No.	Date	Description
1	2025-09-19	Add No. 1
2	2025-09-30	Add No. 2

**WCFPD Station 3**  
**Wright City Fire Protection District**  
9 Highway WW  
Wright City, MO 63390

**ELECTRICAL SITE PLAN**  
 SCALE: 1" = 10'-0"

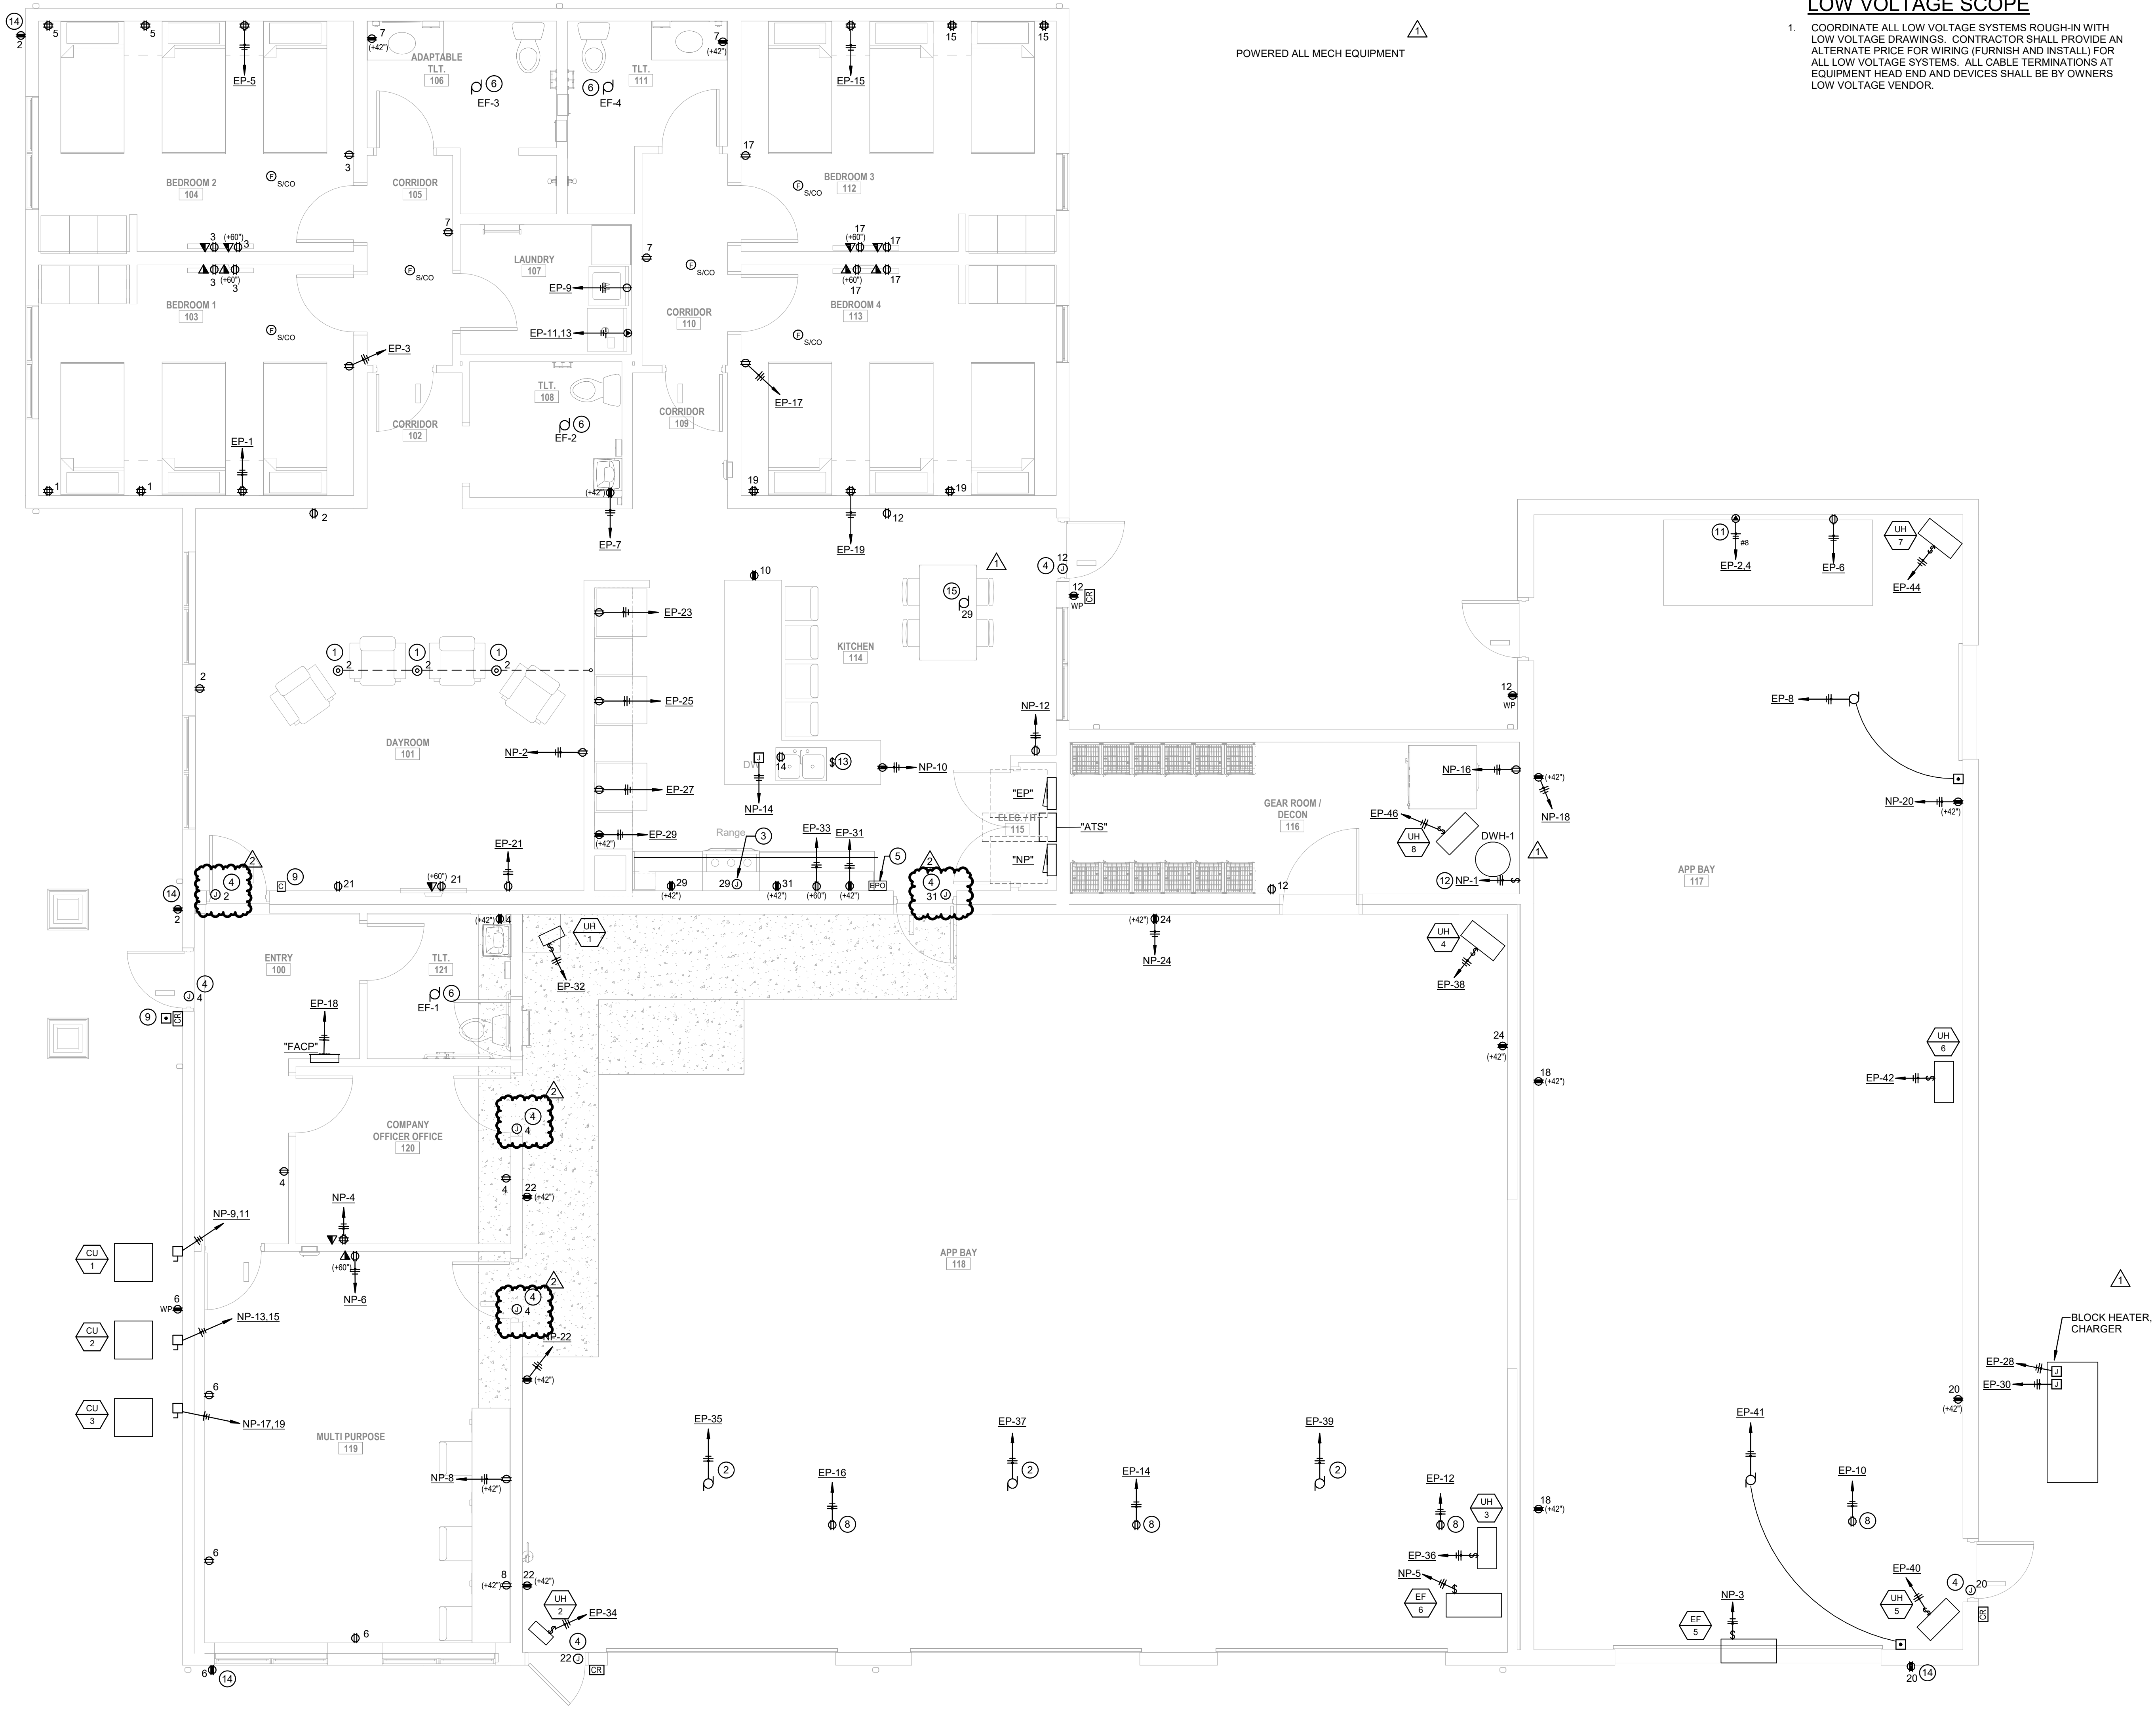
- 38) Sheet E100 – ELECTRICAL SITE PLAN
  - a. ADDED notes about the relocation/disconnect of the House 1 generator.
- 39) Sheet E201 – FLOOR PLAN
  - a. ADDED power for door access controls. Removed note for baby box.
